Permit of Authorization to Construct an On-Site Sewage Facility Permit Valid For One Year From Date Issued

Permit Number: 117197
Issued This Date: 03/28/2024
This permit is hereby given to: CHRISTOPHER & SERIKA RILEY

RE- SEPTIC DESIGN
2214 MERITAGE
VINTAGE OAKS AT THE VINEYARD, UNIT 8, LOT 1089
NEW BRAUNFELS, TX 78132
RILEY RESIDENCE

RE: Permit #117197
2214 MERITAGE
VINTAGE OAKS AT THE VINEYARD, UNIT 8, LOT 1089
RILEY RESIDENCE

OWNER: CHRISTOPHER & SERIKA RILEY		DRAWN BY: EJS III	
STREET ADDRESS: 2214 MERITAGE			
LEGAL DESC: VINTAGE OAKS at the VINEYARD	UNIT/SECTION/PHASE: 8	BLOCK:	LOT: 1089
PREPARED BY: GREG W. JOHNSON, P.E. F#002585	SCALE: 1"=40'	DATE: 2/7/2024	REVISED: 3/26/2024

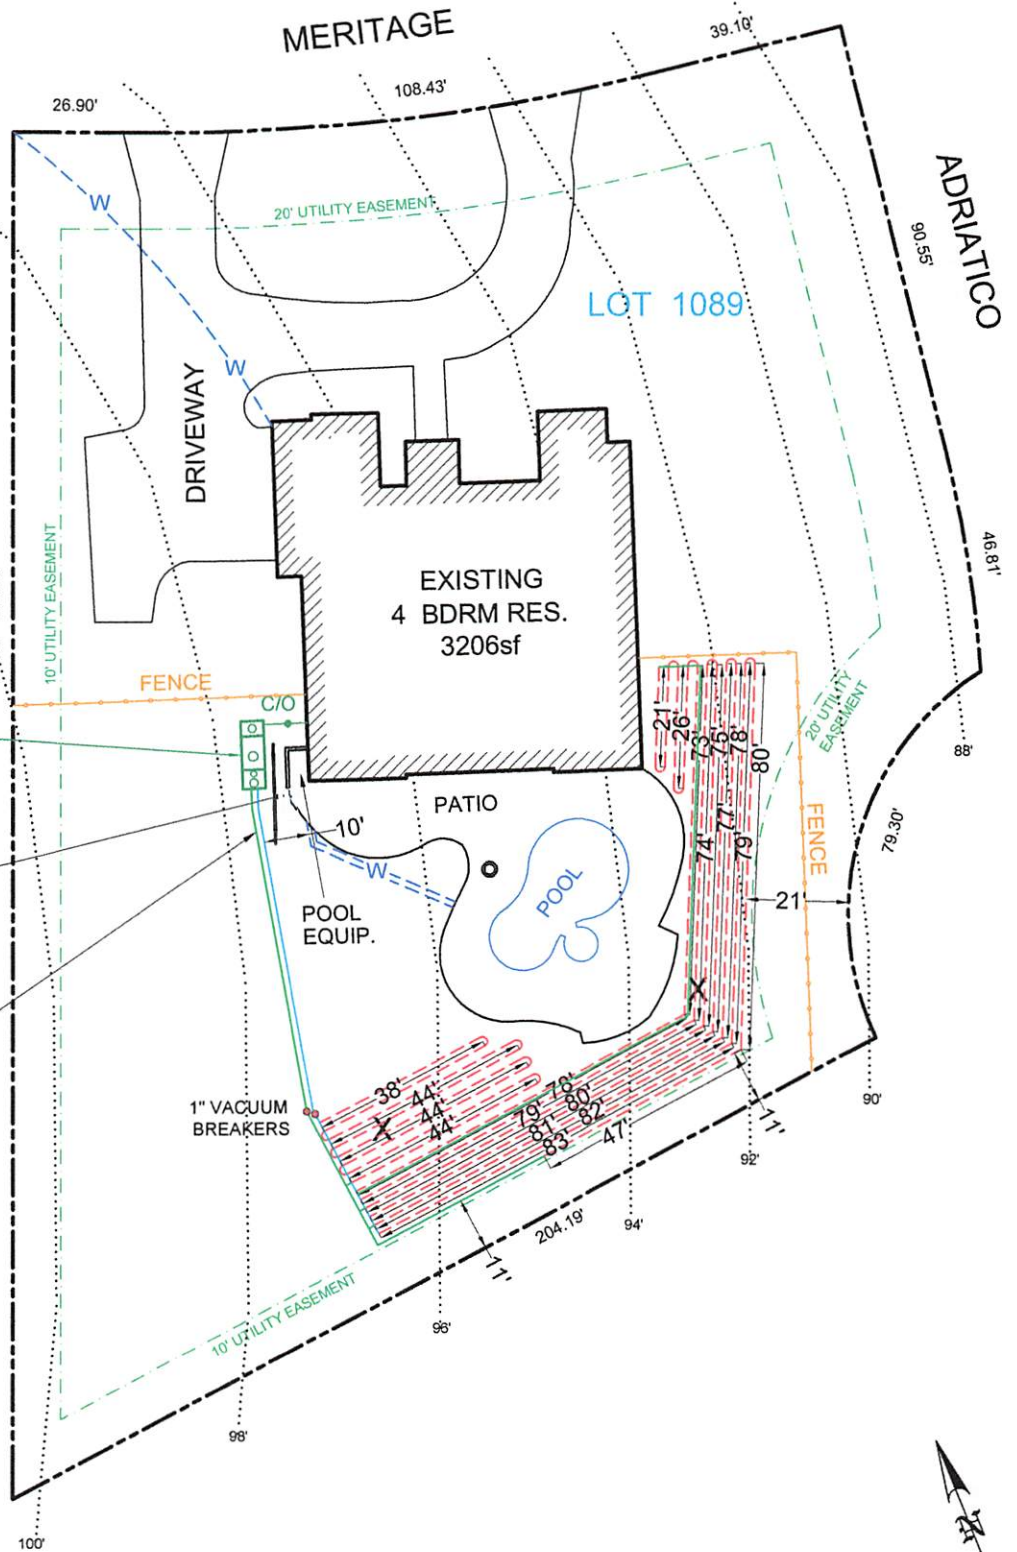
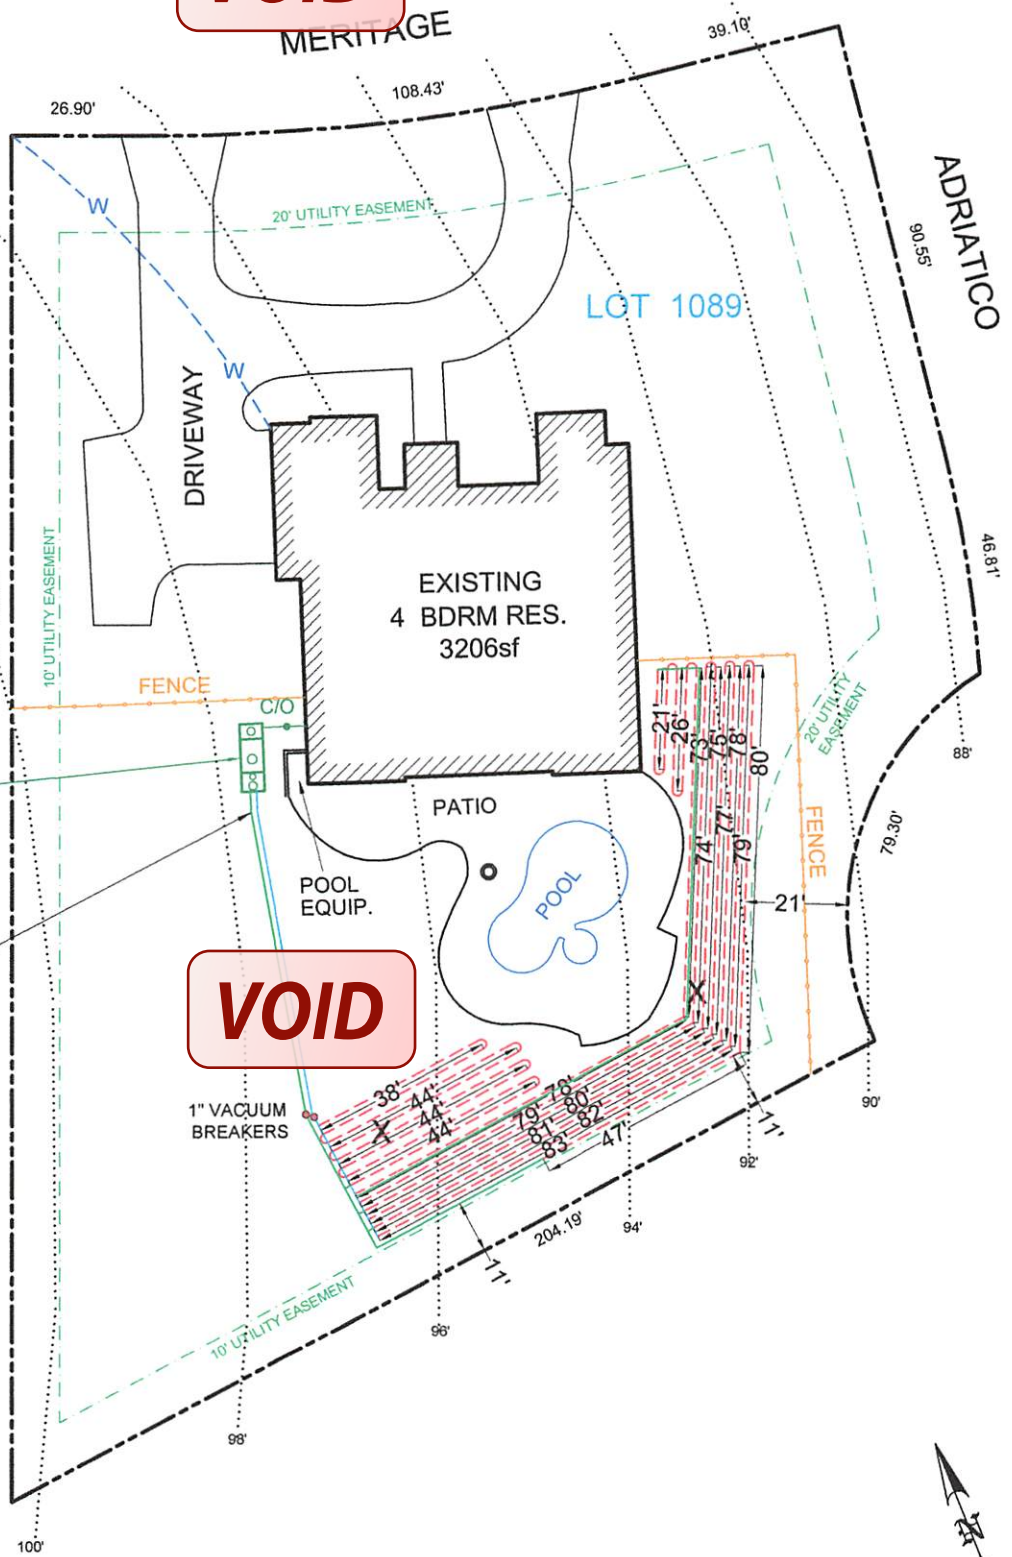
A preliminary inspection conducted on 3/1/2024 found that there is a concrete wall within 5 ft of the tank and pool lines within 10 ft. of the tank. Revise as needed and resubmit.

1.  **All property owners as identified on the warranty deed must sign the permit application.**
2. **Verify that all pool lines will be at least 10 ft. from all OSSF components.**
3. **A preliminary inspection has been scheduled for today. Additional comments may be necessary once complete.**
4. **Revise as needed and resubmit.**

Revised to show concrete filled trench to solid rock between existing pool equipment/pool lines & existing aerobic tank to provide equivalent protection.

Owners have installed a concrete pool equipment pad within 5' of one side of the aerobic tank. The tank was installed before the pool equipment pad was constructed. Placement of the septic tank will not harm the foundation because the tank was installed first and the concrete pool equipment pad is not a foundation. Additionally, the placement of the concrete pad will not negatively affect the integrity of the tank. In my professional opinion the installation of the concrete pad closer than the five foot setback requirement will not pose a threat to the public health or environment. Additionally, the pool lines from the pool equipment pad are less than ten feet from the aerobic tank. I proposed to excavate a fifteen foot long rocksaw trench to solid rock, (~approximately 16" deep) centered between the tank and pool equipment/pool lines and fill with concrete to provide equivalent protection between tank and pool lines.

I hereby respectfully request a variance to five foot setback from tank to the concrete pool equipment pad and ten foot setback between pool lines and aerobic tank.

15' LONG CONCRETE BARRIER
BETWEEN SEPTIC TANK AND
POOL EQUIPMENT DOWN
SOLID ROCK TO PROVIDE
EQUIVALENT PROTECTION.

SLEEVE SEPTIC LINES WHEN
ENTERING CLOSER THAN 10'
FROM POOL WATER LINES
WHICH MEETS TAC 30
CHAPTER 290.44(e)(B)(i).
